The application circuit for Figure 19, the 100W Audio Amplifier, of the **LT<sup>®</sup>1166** data sheet has two corrections as indicated below. For complete specifications, typical performance characteristics and applications information, please see the **LT1166** data sheet.

### The Corrected Schematic:

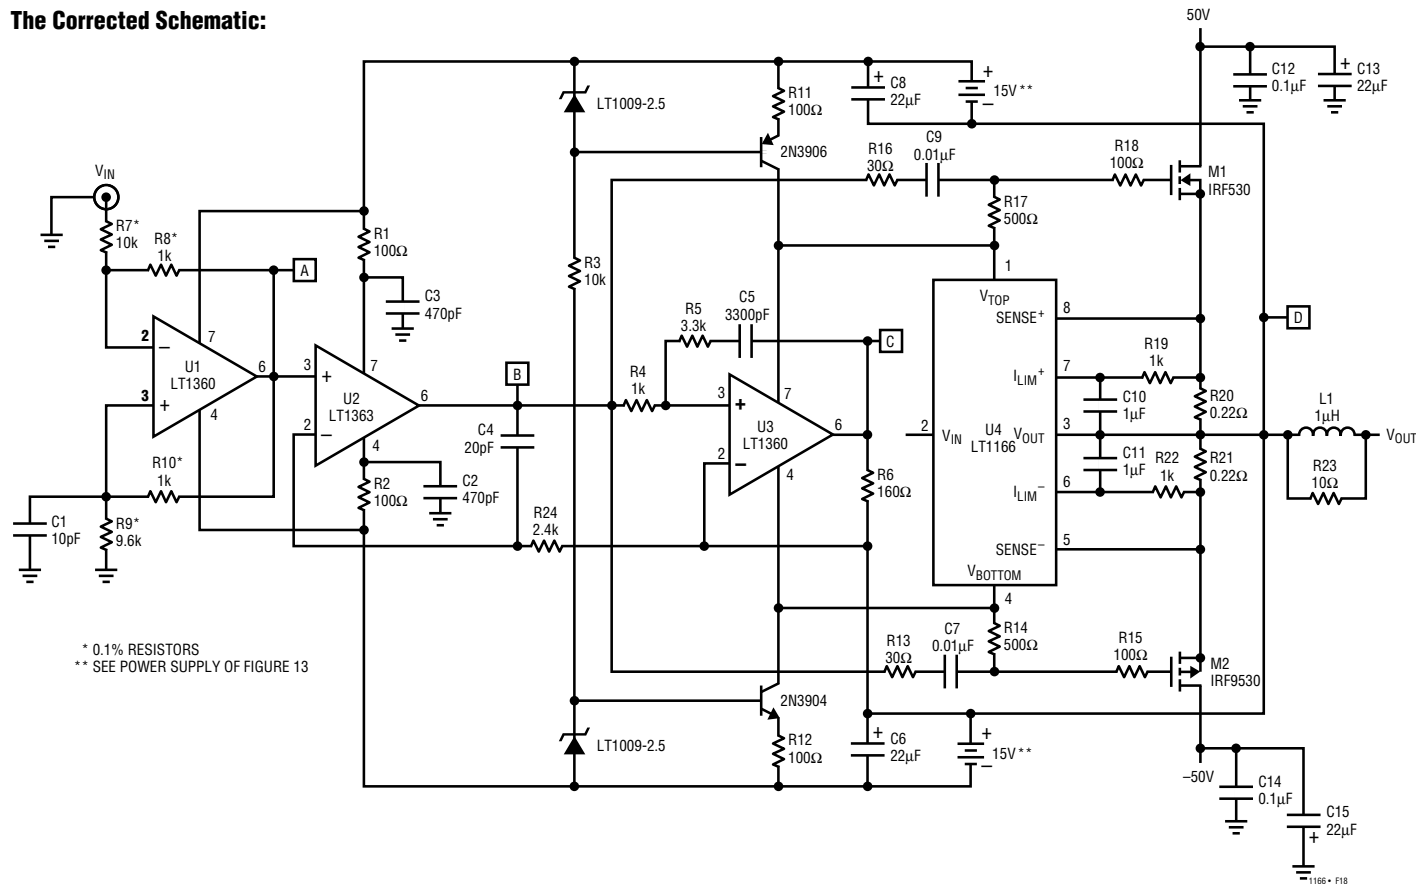
### Changes Made in the Schematic:

- 1) U1, LT1360: changed Pin 3 to Pin 2; changed Pin 2 to Pin 3
- 2) U3, LT1360: changed + sign to – sign; changed – sign to + sign
